**CERTIFICATE OF APPROPRIATENESS**

**Property:** 501 Highland Street, Lot 16, Block 9, Woodland Heights Subdivision. The property includes a historic 1,654 square foot two story residence and two story garage-apartment situated on a 5,000 square foot (50' x 100') corner lot.

**Proposal:** Alteration – Revision. Replace all existing windows previously approved to remain with new single-pane, 1-over-1, double-hung wood windows. The windows have already been removed without the knowledge of staff or HAHC approval. All windows have since been destroyed and staff is not able to properly assess their condition and to confirm if they are/were damaged beyond repair.

**SOUTH ELEVATION – FRONT FACING HIGHLAND STREET**

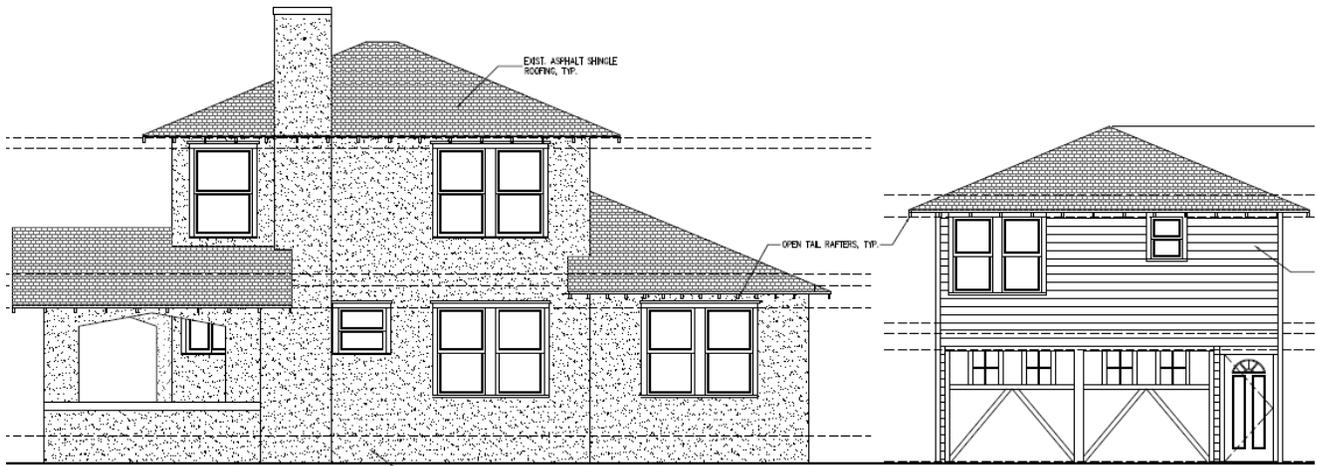
|                                     | <input checked="" type="checkbox"/> | <input type="checkbox"/>            | (1) The proposed activity must retain and preserve the historical character of the property;<br><i>Replacing the original windows with new windows does not retain and preserve the historical character of the property.</i>                                                                                                                                                                                                                                                                                                                                                                                                                                                                                  |
| <input type="checkbox"/>            | <input checked="" type="checkbox"/> | <input type="checkbox"/>            | (9) The proposed design for any exterior alterations or addition must not destroy significant historical, architectural, archaeological or cultural material, including but not limited to siding, windows, doors and porch elements;<br><i>Replacing the original windows with new windows destroys significant historical architectural material. The windows should be retained unless they are damaged beyond reasonable repair. Staff was not able to evaluate the condition of the windows prior removal. As these windows have been intact throughout the duration of the project (since January 2015), without mention of damage, staff believes it unlikely that they were damaged beyond repair.</i> |

**Recommendation:** Denial - does not satisfy criteria 1 or 9. Staff also recommends a Certificate of Remediation for the window removal. A Certificate of Remediation will allow the project to progress without the Commission approving the unauthorized removal of the historic windows or deeming the unauthorized work appropriate.

KEYED WINDOW MAP

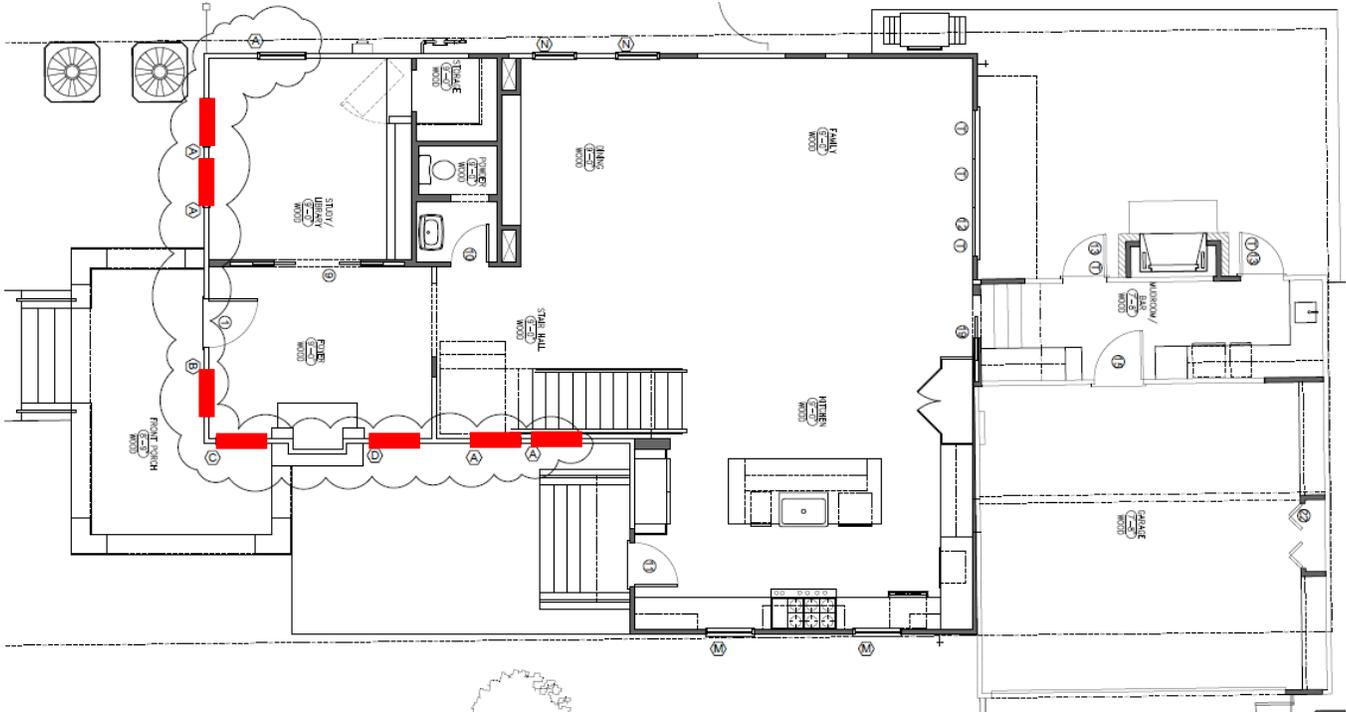
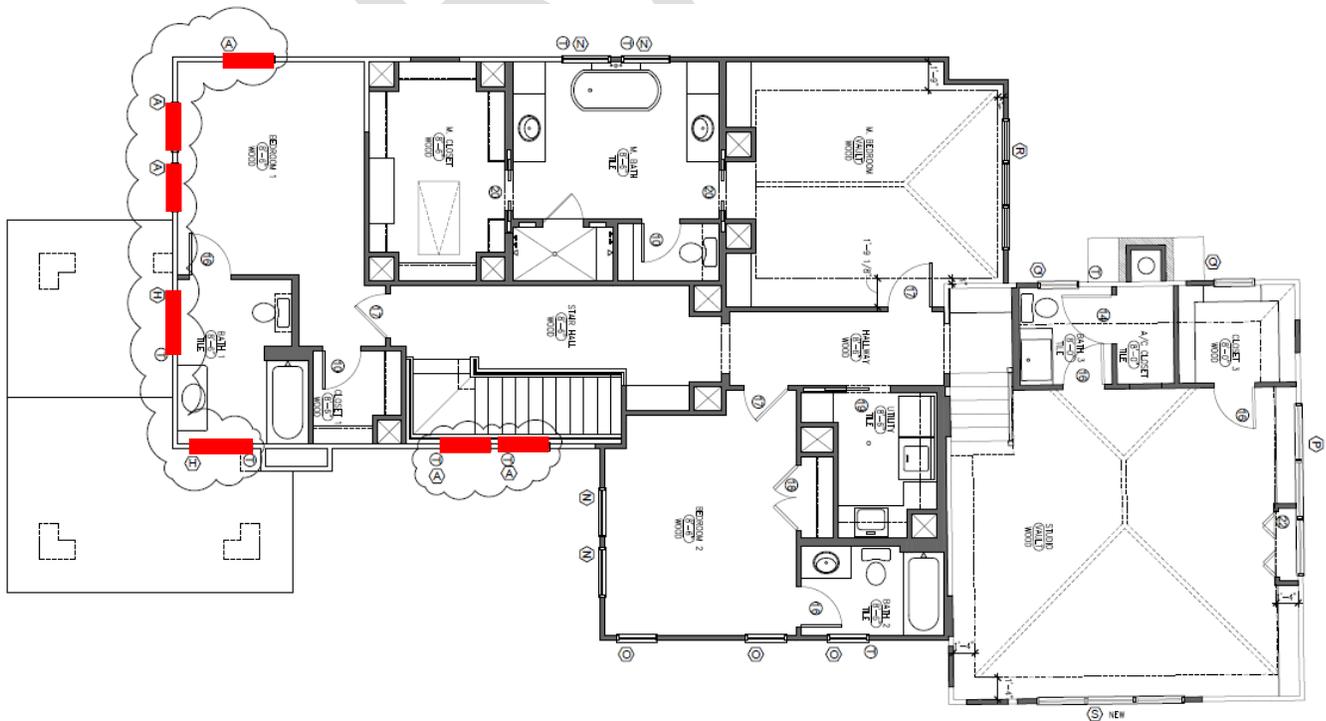
**Windows** The existing original wood windows, which were to remain, were removed and replaced with new 1-over-1, double-hung, single-pane wood windows. The new windows are inset and rebuilt using the existing weights and pulleys.

The applicant asserts that the existing windows were damaged beyond repair due to numerous previous infractions and destruction of historic materials, including the unauthorized removal or shiplap. Staff was not able to verify the condition of the windows since they were removed from the site prior to a staff inspection. The windows were essentially the last remaining historic material of the house since all other historic material has since been replaced, both with and without prior HAHC approval and staff knowledge. See drawings and other supporting information for more detail.
